# **Review of Model Plans for the John F. Baldwin Ship Channel Project**

*by The Committee on Tidal Hydraulics*

Final report

Prepared for U.S. Army Engineer District, San Francisco  
San Francisco, CA 94105-1905

Figure 25

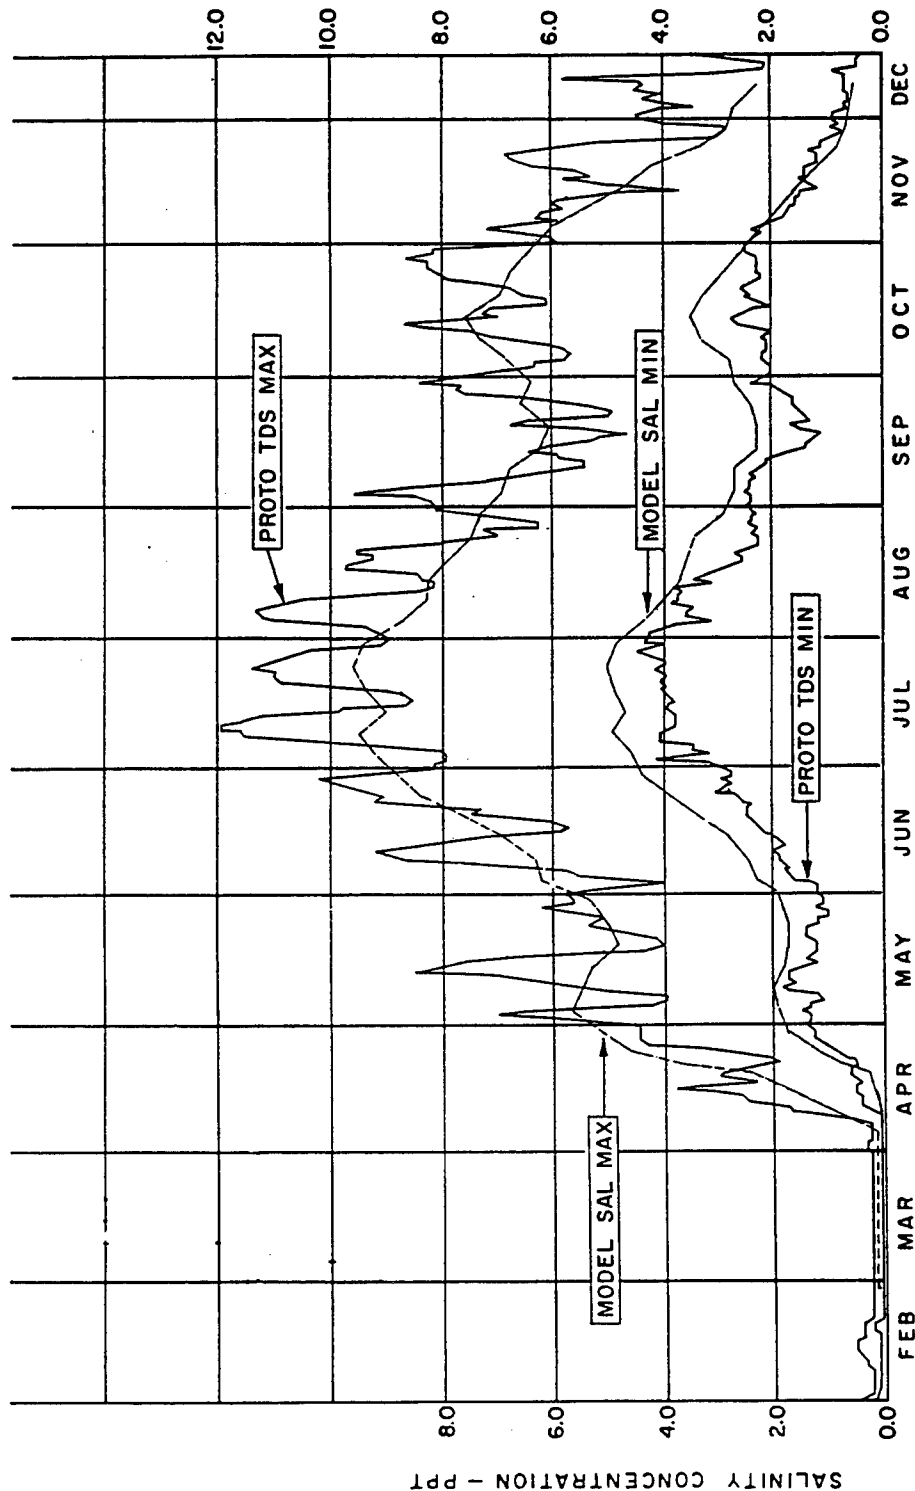
Comparison of modeled salinities using a repeated mean tide and prototype salinities at Pittsburg is shown by Figure 25 from Reference (1). This figure shows that the spring/neap cycle causes significant variations in the maximum salinities that occur during a tidal cycle (as much a 100% at this location). The water projects are managed on a tidal basis and changes of salinity during the spring/neap cycle may become more important to water transfer operations as restrictions on water diversion increase. Further, the maximum salinities during the spring/neap cycle may impact the quality of water in Delta channels.

The averaged model salinities plotted in Figure 25 also have a smaller maximum-minimum range than have the prototype salinity variations. This difference can be due to differences of vertical mixing by a repeated mean tide and those produced by a spring/neap cycle. Similar effects can be expected at lower salinities upstream. It can be concluded that facilities that provide a variable tide would significantly enhance the accuracy of model predictions and would make model tests more useful for water agency operation studies.

A repeated spring/neap tide cycle would be a step toward a real prototype boundary condition and may be appropriate during model adjustment. However, a runup using recorded or predicted tides prior to an event of particular interest to regulatory agencies may be required to meet their concerns.
